**MAJOR PROJECT ASSESSMENT:
Sydney Children's Hospital
High Street, Randwick
(MP 10_0096)**

Director-General's
Environmental Assessment Report
Section 75I of the
Environmental Planning and Assessment Act 1979

April 2011

Figure 9: Western elevation with surrounding hospital buildings

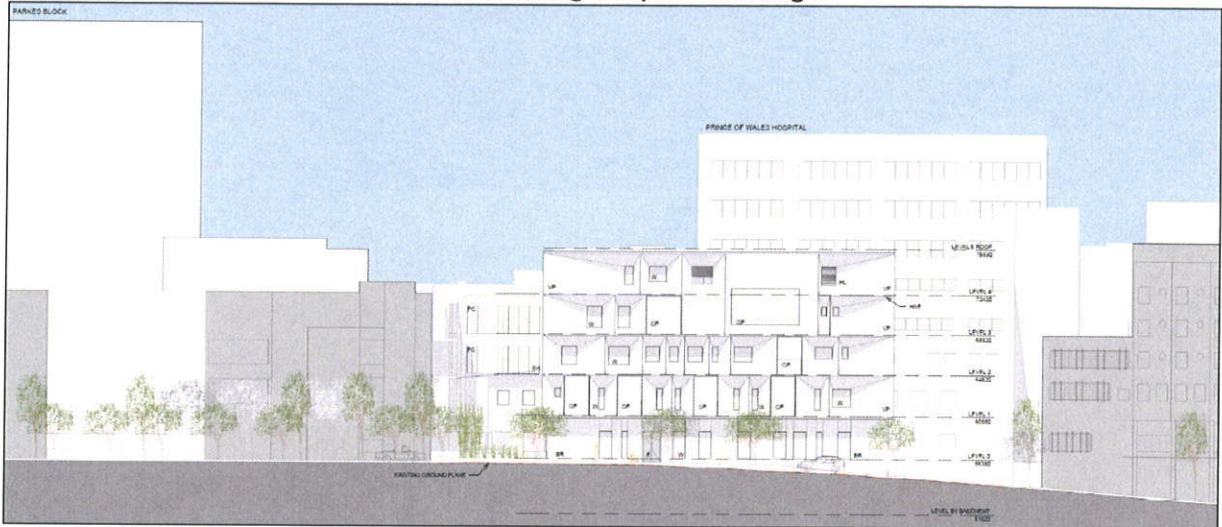
The Department considers the new building at five storeys is comparable in height and scale with the surrounding hospital buildings which vary from four to eight storeys. Furthermore, the five storey building would provide an appropriate transition along Hospital Road from the existing four storey SCH building to the six storey Royal Hospital for Women building to the south (see Figure 9). The existing hospital buildings on the Campus reach a height of RL 94.81 metres and the proposed building at RL 76.83 is below the highest building on the site.

**Figure 12: Overshadowing - Winter Solstice
9.00am**

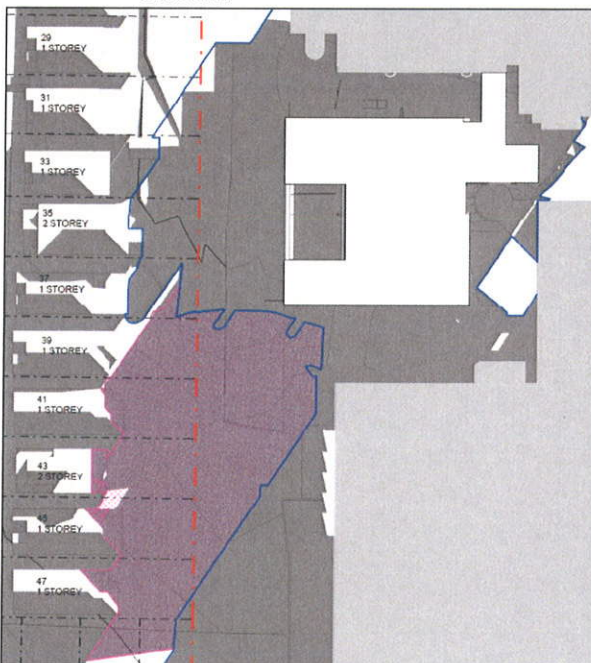
The proposal would have overshadowing impacts on the rear of the residential properties to the west. The overshadowing impact during the winter solstice would occur between 9am and approximately 10am (see Figures 12-15). The residential properties to the west would still maintain a minimum three hours of sunlight during the winter solstice in any living rooms at the rear of the properties and a minimum three hours of solar access to the rear yards of these properties, which is consistent with relevant principles and guidelines for solar access. Accordingly, the Department considers the overshadowing impacts of the proposal acceptable.
